City of Mississauga Department Comments

Date Finalized: 2023-06-14	File(s): A766.22
To: Committee of Adjustment	Ward: 2
From: Committee of Adjustment Coordinator	Meeting date:2023-06-22 1:00:00 PM

Property Address: 2488 Selord Crt

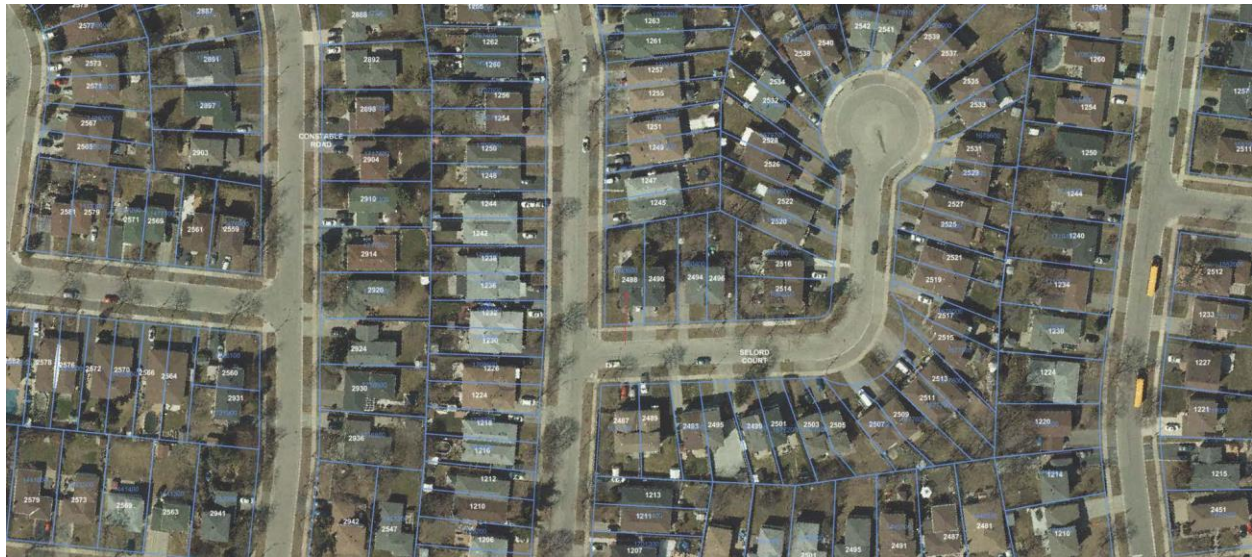
Enclosed for Committees easy reference are photos of the existing driveway. We have a concern with the applicant's proposal. The vehicle in the picture will be unable to manoeuvre in and out of the parking spot without damaging the existing sod within the Municipal boulevard. Furthermore, a portion of the boulevard where sod was present has been paved over.
